Report on NIPSCO's 2024 Integrated Resource Plan

**Submitted to the IURC on April 17, 2025
Confidential Information Redacted**

**On behalf of Citizens Action Coalition,
Earthjustice, Solar United Neighbors, and Vote Solar**

EFG Report on NIPSCO's 2024 IRP on Behalf of Joint Commenters Submitted to the IURC on April 17, 2025

Figure 1. MISO Zone 6 ATC Power Prices across Scenarios¹⁴

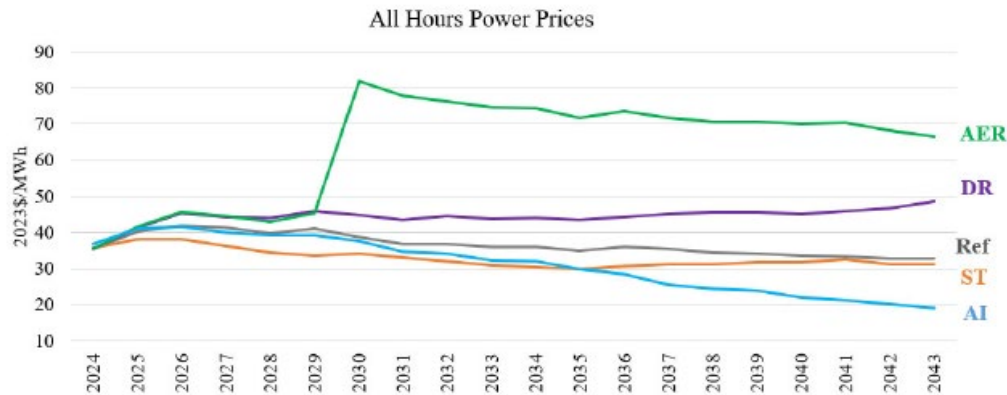
A power price forecast based on a zonal model is unable to adequately quantify risk or reliability given what appears to be a major need for NIPSCO to import power into its service territory in the near term to satisfy both its current native load and projected load growth. Both NIPSCO's Schahfer Generation Station and Sugar Creek Generation Station are away from NIPSCO's primary load centers. Given the nature of the data center load (near constant 24x7), it is necessary to understand potential generation resource additions based on both energy and congestion.

We do not believe that this type of power price risk can be captured through market price forecasts developed for the scenario specific evaluations included in the IRP. NIPSCO found that the Reference Case expects power prices to be relatively flat in the near-term as a result of the natural gas and power price assumptions whereas longer-term prices see a decline from an increase in renewable generation resources.¹³ NIPSCO also developed different market price assumptions based on the different scenarios evaluated as part of the IRP. Figure 1 shows a comparison of the market prices across the scenarios modeled by NIPSCO. Since each of these scenarios include assumptions around commodity prices, it is likely that differences in power prices are driven by those commodity price changes and not necessarily from higher load.

It is not clear what analysis NIPSCO might already do around new load additions, but we recommend that, before any major resource decisions are made or in future IRPs, NIPSCO perform an analysis that includes nodal modeling to evaluate the impact that new large load additions may have on the market price forecasts that will be used for developing portfolios.

Figure 5. NPVRR for Flat Load Portfolios⁵³

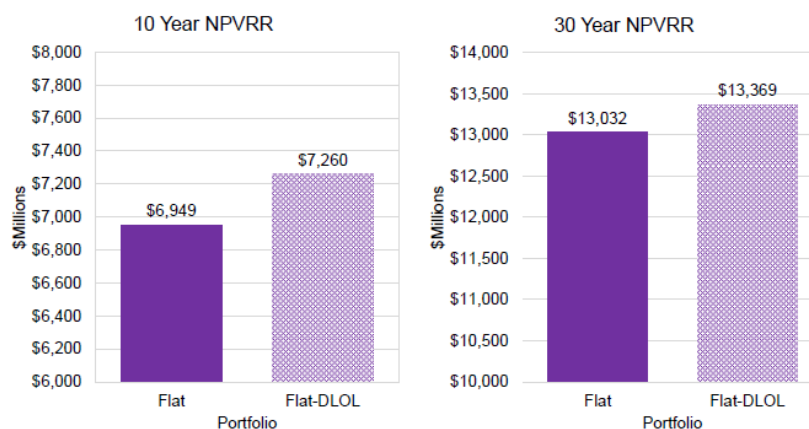
On a cost basis, the Present Value of Revenue Requirements (“PVRR”) is significantly less for the Flat Load portfolio due to the lower level of load, as Portfolio D has a PVRR of \$10.7 billion over 10 years and almost \$26 billion over 30 years.⁵² Figure 5 shows the 10-year and 30-year PVRR comparison for the Flat Load portfolios under the Current and DLOL MISO capacity accreditation.

Figure 6. Levelized Portfolio Costs for Reference Case and Flat Load Portfolios under D-LOL Market Rules⁵⁵

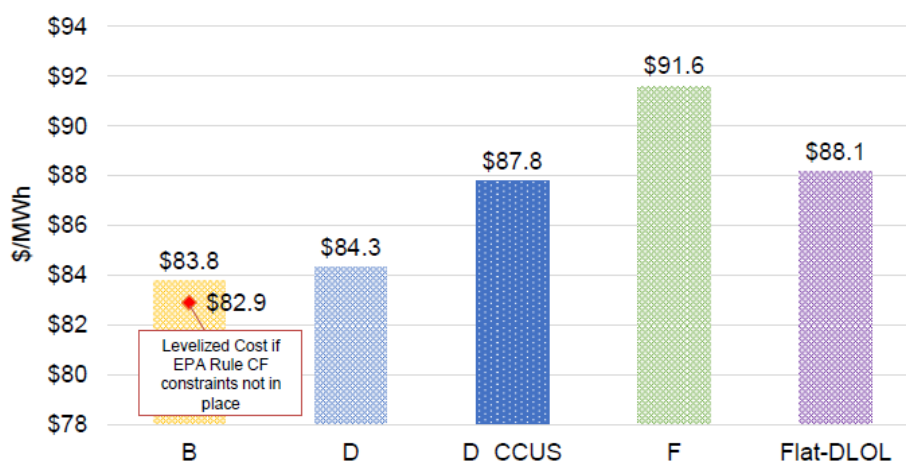
the Reference Case load outlook can be spread over more MWh, such that the per MWh system cost goes down.”⁵⁴ The result of the levelized cost for portfolios is shown in Figure 6 below.

While this calculation does show a higher \$/MWh system cost based on the AURORA modeling results, it does not represent the question of cost allocation and recovery. If the load included in the Reference Case forecast, and reflected in the calculation for Portfolios B, D, D_CCUS, and F in Figure 9 does not materialize, then this calculation would not hold, and NIPSCO’s existing customers would bear the costs of the full portfolio without being “spread over more MWhs”.

Figure 7. NPV for Enhanced RAP or MAP for Portfolio D⁵⁹

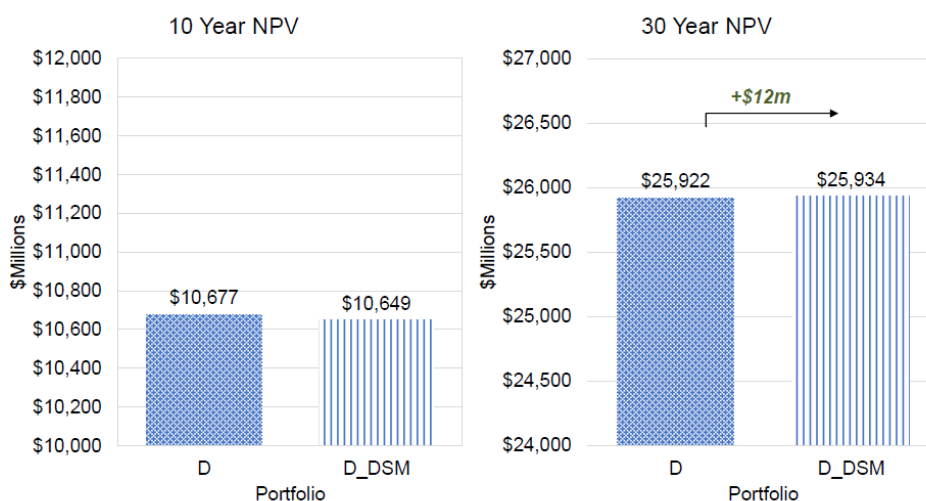
Figure 7 shows the PVRR results for Portfolio D, which only includes the RAP level of energy efficiency and demand response, to Portfolio D_DSM, which includes the enhanced RAP level of energy efficiency and the MAP level of demand response. Including the Enhanced RAP of energy efficiency and MAP for demand response resources results in a \$28 million reduction in the PVRR over a ten-year period, but a \$12 million increase over the 30-year PVRR. It is possible this change in result is driven from the approach NIPSCO used, which was to defer 75 MW of peaking capacity in the 2030 timeframe, but no other deferred resources outside of that time period.

We appreciate the DSM sensitivity that NIPSCO performed for this IRP; however, we would recommend a change for this process prior to moving forward with any major resource decisions. The enhanced RAP level of energy efficiency should be considered a resource option that can be selected in the portfolio optimization stage so the model can select between the RAP and Enhanced RAP levels. However, as discussed in the next section, there may be some further investigation of the selection around energy efficiency bundles in AURORA. In the event that Enhanced RAP levels are not selected in AURORA, we support forcing in the Enhanced level of RAP for energy efficiency bundles to be able to evaluate their impact on the PVRR.

Figure 10. C&I Lifetime Energy Efficiency Savings, RAP vs. Enhanced RAP

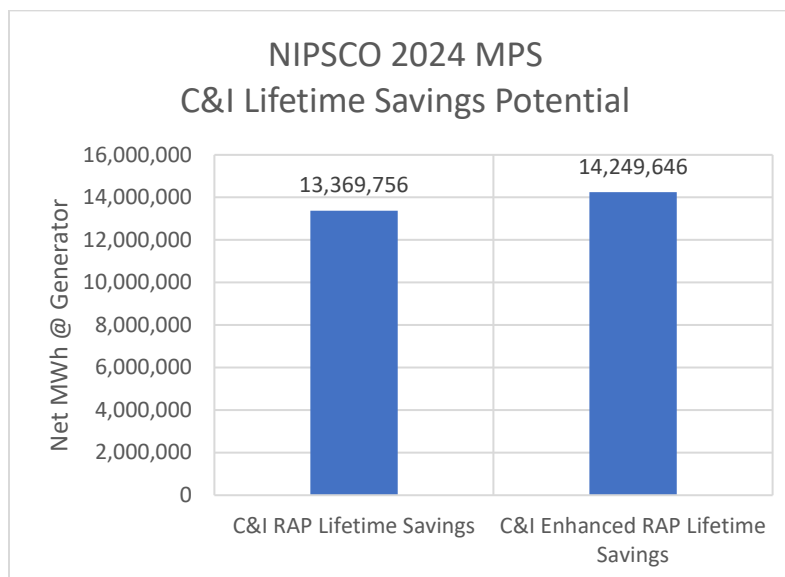
The impact of this approach is a **potential loss of 7% more C&I energy efficiency savings**, shown below in Figure 10. As noted by NIPSCO, the savings contained within the enhanced RAP are more expensive, though we believe the C&I enhanced RAP bundles would have been economically competitive considering the overall low costs of C&I energy efficiency.
